OBJECTION TO MAJOR PROJECT APPLICATION - MP09_0210 COMMERCIAL DEVELOPMANT

**No. 88 Christie Street
St Leonards**

Prepared for:
Australian Dental Association (NSW Branch)

**SUBMISSION - PART 3A MAJOR PROJECT - 88 CHRISTIE STREET, ST. LEONARDS
(DOP REF: MP 09_0210)**

Figure 3: Proposed Height

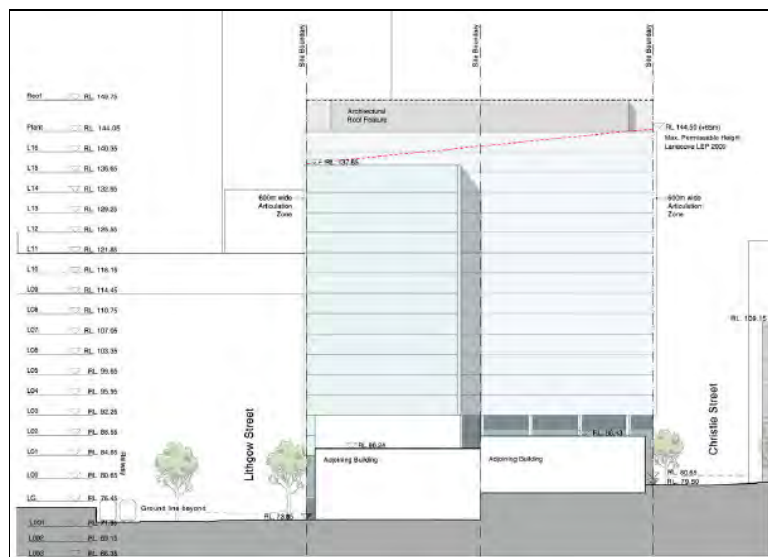
The proposal is contrary to the Lane Cove Local Environmental Plan 2009, which came into force on 19 February 2010. Clause 4.3 of the LEP relates to height of buildings and states that the height of a building on any land is not to exceed the maximum height shown for the land on the Height of Buildings Map. The maximum height for the subject site is 65m. The Concept Plan proposes a maximum height of 65m at the Christie Street frontage, which complies with the development standard. However, the maximum height at the Lithgow Street frontage is 69.25m, which exceeds the LEP provision by approximately 2 storeys (see Figure 3).

The subject site falls approximately 7m from Christie Street to Lithgow Street and approximately 3m from north to south. The proposal, with a non-complaint height at the Lithgow Street frontage (69.25m) does not respond to the topography of the site and is inconsistent with the objectives for the LEP development standard.

Figure 6: Concept Plan

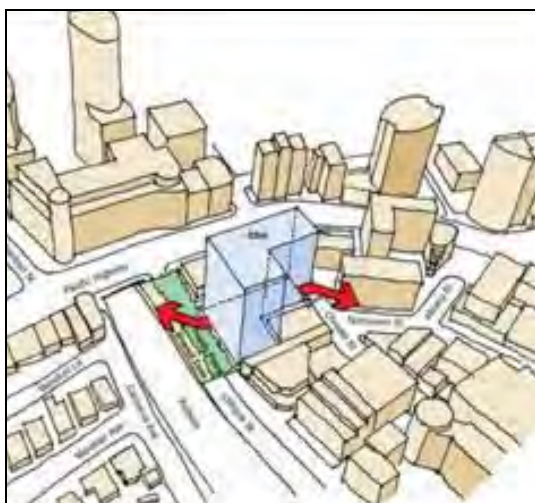
The proposed Concept Plan for the subject site does not comprise a podium and tower built form and is inconsistent with the DCP (see Figure 6). The proposal provides a 5.29m setback to Lithgow Street and a 5.29m setback to Christie Street, which does not comply with the DCP control. The DCP also requires a maximum tower footprint of 1,600m² and height of 65m. The Concept Plan proposes a tower footprint of 2,220m² and a maximum height of 69.25m and does not comply.

The proposed design does not have regard to the existing built form of the site and surrounds and does not comply with Council's precinct controls. Accordingly, the proposal is inconsistent with the DCP

Figure 2: Existing Views from Challenger Property

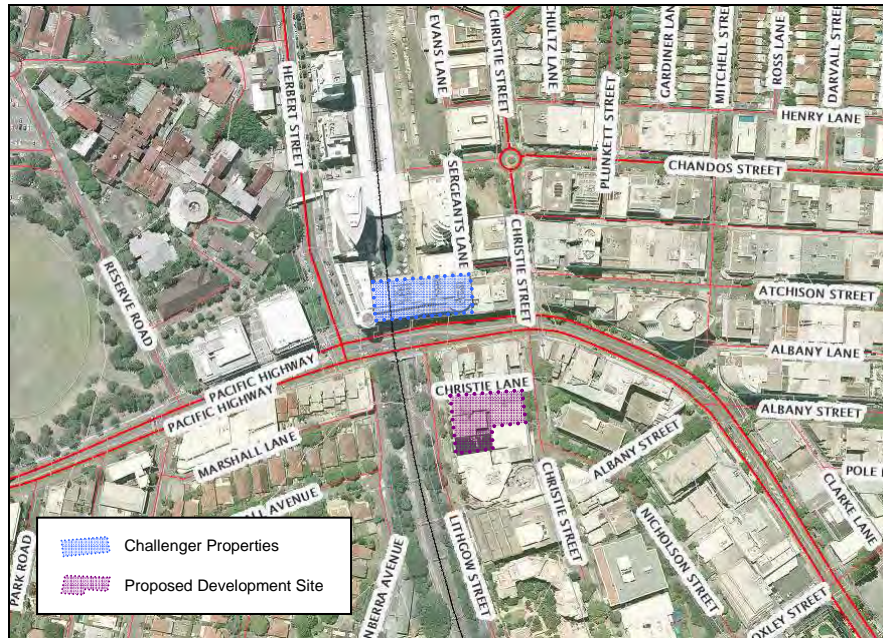
Currently, these properties enjoy significant southerly views as illustrated in Figure 2, including direct primary views of the Sydney Harbour Bridge and CBD skyline. These views have been a primary factor in the consideration of tenants when choosing to locate or remain within Challenger's buildings.

Our review of the proposal has concluded these direct views will be largely blocked by the proposed development. Accordingly, this will impact on the ability to lease tenancies within the buildings and diminish our client's property value (current market value in excess of \$160 million), potentially resulting in considerable financial loss. Our review also concludes that if the proposed development was to comply with the setbacks contained within the DCP (particularly the 18m tower setback to Lithgow Street) that these impacts would be significantly reduced.

Figure 1 – Estimated View Loss from a DCP Envelope

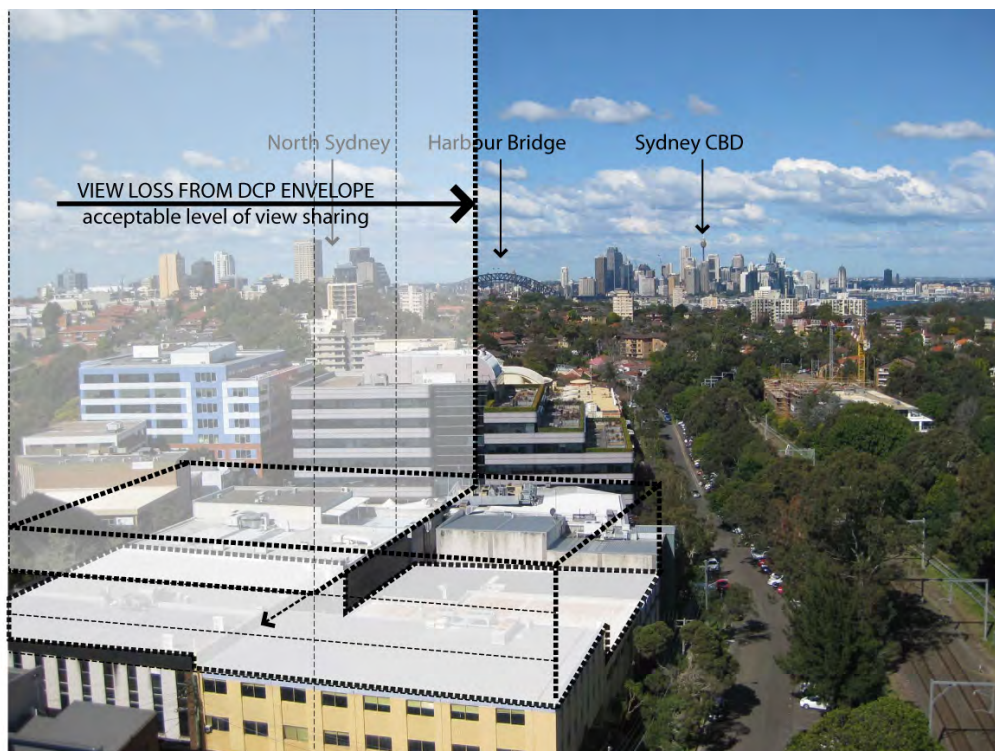
In this case, the views of an **icon** (the Harbour Bridge), from the **front** boundary, that results in a **severe** loss of view (noting that some CBD views are retained), due to a development that **breaches** planning controls, would appear to be a classic case of an unreasonable view loss. The difference between a DCP compliant scheme and the proposal is illustrated below as an overlay to Figure 2 of the Objection.
